Wisconsin Department of Transportation

Proposal #02: 1007-11-74, WISC 2018 001
Illinois State Line – Madison
S. Dane Cty Line to E. Church Rd, SB
IH 39
Dane County

This is Addendum No. 01, which provides for the following:

**ADDENDUM NO. 01
1007-11-74
November 28, 2017**

Addendum No. 01
 ID 1007-11-74
 Revised Sheet 56
 November 28, 2017

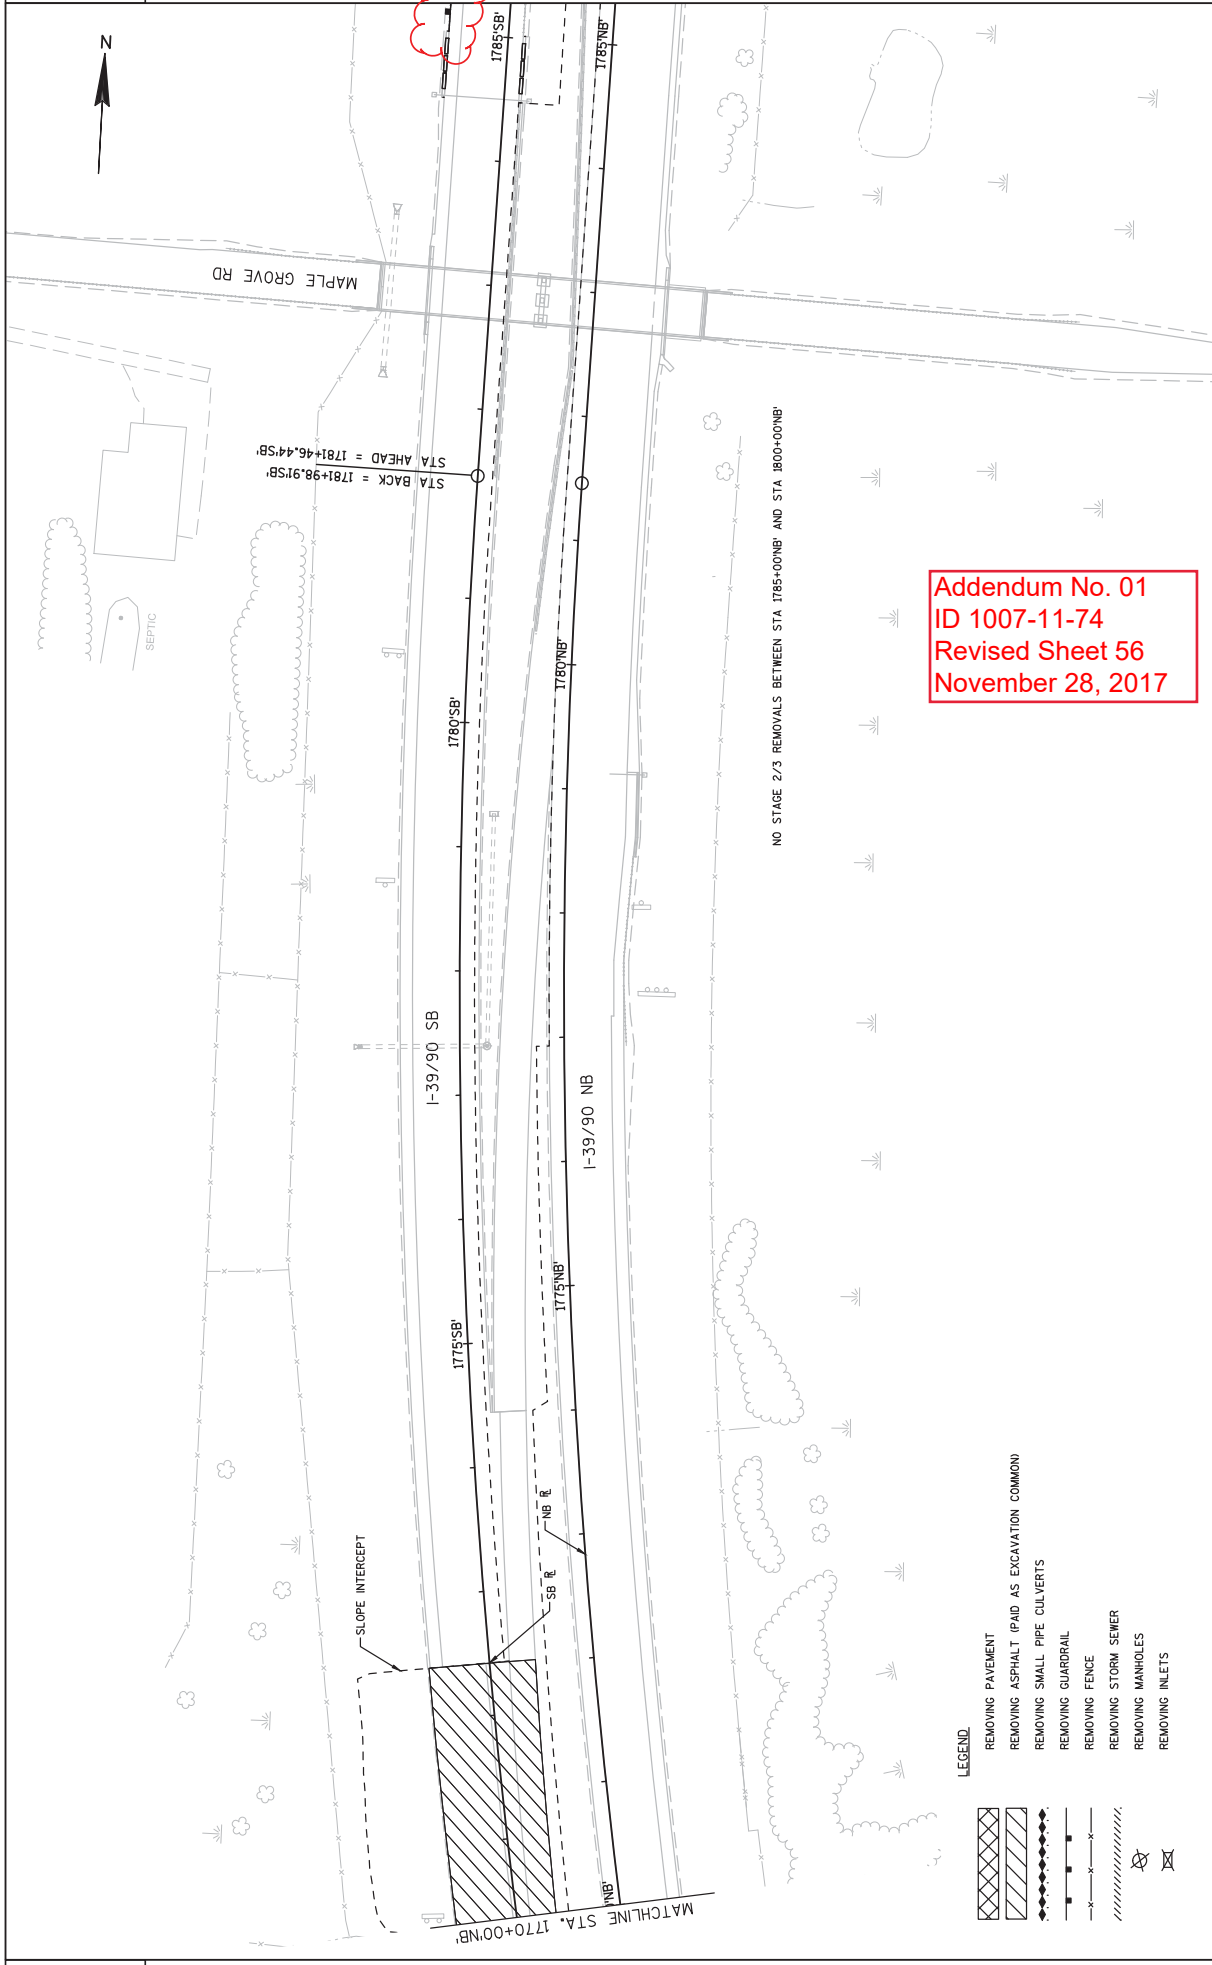
Revised Plan Sheets	
Plan Sheet	Plan Sheet Title (brief description of changes to sheet)
41, 56, 57, 66	Removals (Added Removing Masonry, Guardrail, CBTP, and Crash Cushion)
144, 145, 169	Plan Details (Added new guardrail, thrie beam transition, and EAT)
400-402, 405, 411, 413	Miscellaneous Quantities (Added/Revised items)
